Project	The Hall School, 23 Crossfield Road NW3 4NU	Project Ref	G1701
Subject	Planning Application 2016/6319/P	Date	08/02/17

1. This advice comprises a limited review of the subterranean elements of planning application 2016/6319/P to Camden Council, and my opinion of its compliance with the Council's planning policy DP27(a). It has been prepared for the *Hall School Opposition Group* comprising the owners of the majority of houses in the 24-30 Crossfield Road terrace, Nos. 50 and 52 Eton Avenue and garages serving Eton Court and others. My instructions to prepare the advice for the group were given by Mr Kay of 26 Crossfield Road.

FIGURE 1 Existing arrangement of 24 Crossfield Road 1998

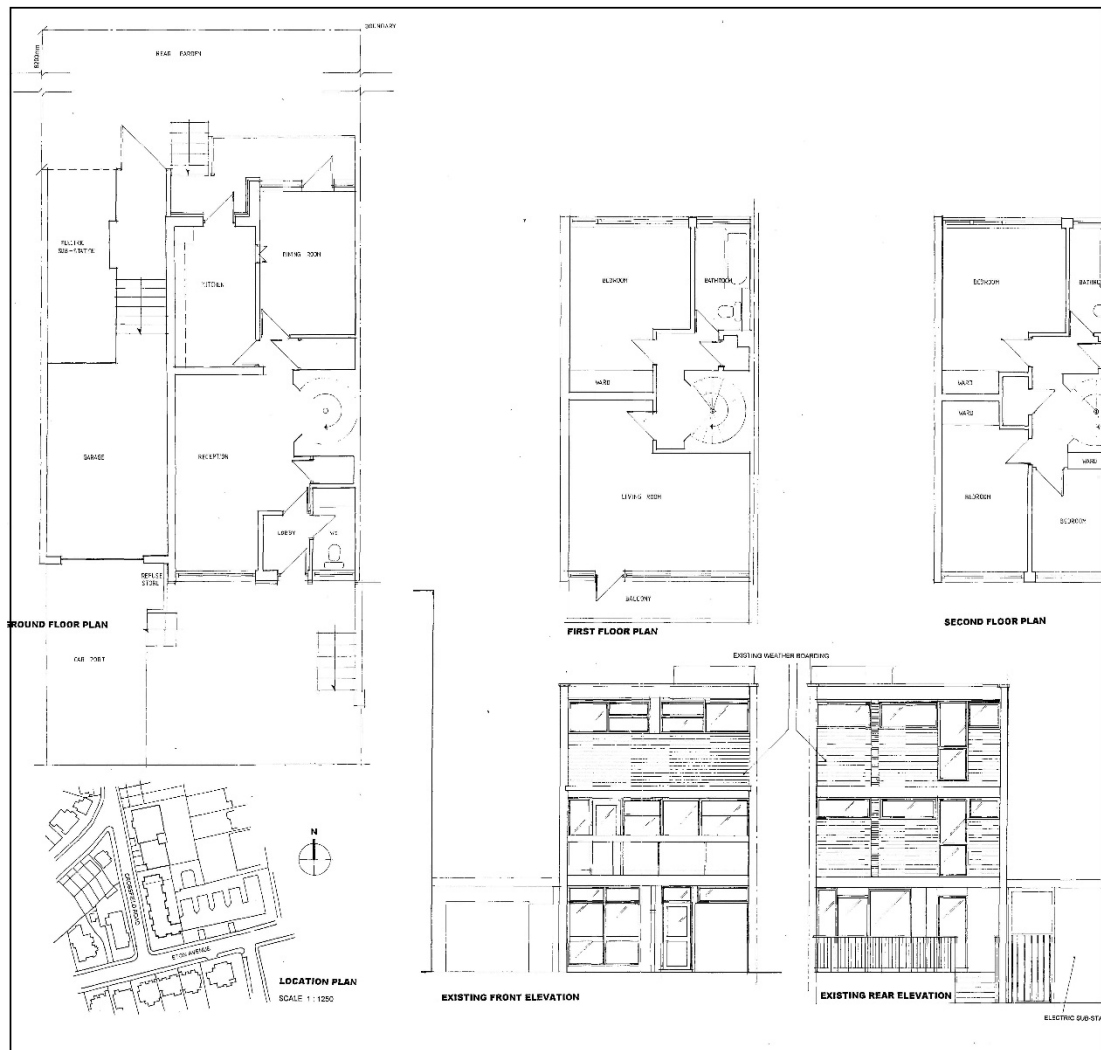
37. Figure 1 below is taken from a 1998 planning application for No.24 and shows the arrangement of the property at that time. The application was to remove the garage and extend to the boundary. It was refused and so the current arrangement is unlikely to differ very much from that shown.

- The construction of the front and back walls of the houses is of material significance for this case. Like many other housing terraces of the time, it followed the architectural fashion to have glazing that extended for the full width of the houses at all floor levels, with tiled or other probably non-brickwork apron walls below.

38. In this case it can be seen that most of the glazing and doors in the ground floor of No. 24 are full height on both elevations. On the front elevation there is at least one full height opening to the balcony and possibly a full height glazed panel. On the rear elevation there are full height glazed panels at both first and second floors.

39. Solid parts of walls between and below these openings were difficult to stabilise if made of brickwork and so were often timber framed, the frames being made on site and supported by being fixed to verticals between openings and to party and flank walls. Usually, as in this case, there were no continuous internal cross walls and it

was only the structure between openings in the front and back walls that provided lateral stability to the terrace as a whole and stopped the "pack of cards" effect.
